Office Action Summary

10/648,305

JUNKER ET AL.

DETAILED ACTION

Applicant's Figure 9

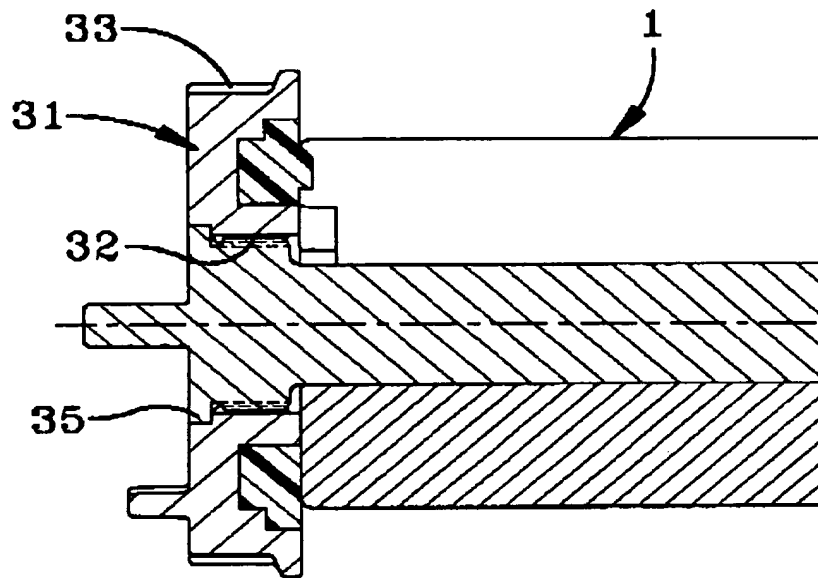
4. Applicant's arguments filed 3/23/06 have been fully considered but they are not persuasive. The applicant argues: "Claim 1 as amended recites the circumferential groove (5) extends into the bar material more deeply in a radial direction than the gear. Furthermore, this is as is shown in each of figures 1,4, and 5-10. More particularly, the

tool 10 in figure 9 shows the projection 12 which forms the groove 5 on the gear 2 clearly extending much deeper radially inwardly than the gear teeth to form a circumferential groove having a side boundary surface on the flange and a side boundary surface adjacent to and radially deeper than the gear. Bell et al. show in figure 2 a torsion bar wherein the gear teeth project outward from the torsion bar and the space between the flange 35 and the gear is not shown deeper than the gear teeth. As a result the alleged groove, if such a space could be considered a groove, does not have a side boundary surface adjacent to or radially deeper than the gear.” Bell Figure 2, and Applicant’s Figure 6 have been included below for convenience.

Bell et al. Figure 2

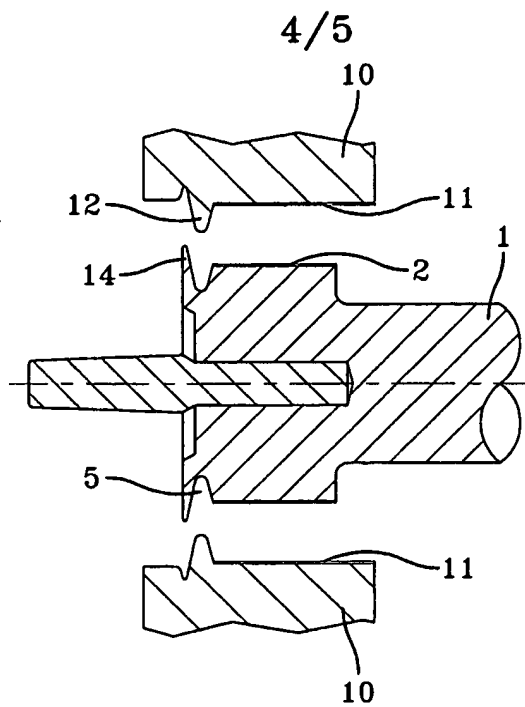
Bell et al. figure 2 clearly shows a long narrow circumferential channel between flange (35) and the gear teeth (32) shown in cross section. This groove, as shown in Figure 2, extends into the torsion bar more deeply in a radial direction than the adjacent gear crest. Furthermore, the circumferential groove has a side boundary surface on the flange and a side boundary surface adjacent to and radially deeper than the gear (as best understood) as can be seen in figure 2.

Because the groove between the flange (35) and the gear teeth (32) is defined by; a sidewall comprised of the flange (35) itself, a lower portion comprised of the torsion bar itself, and a radially higher adjacent sidewall comprised of a radially lower

portion of the gear (as best understood), the groove is considered by the examiner to extend into the torsion bar more deeply in a radial direction than the adjacent gear (as best understood) and has a side boundary surface on the flange and a side boundary surface adjacent to and radially deeper than the gear (as best understood).

5. The applicant further argues: the space between the flange 35 and the gear is not shown deeper than the gear teeth.

In response, the groove, having a side wall comprised of a radially lower portion of the gear, is clearly shown deeper than the radially higher crests of the gear teeth and therefore is also considered by the examiner to be radially deeper than the gear (as best understood).
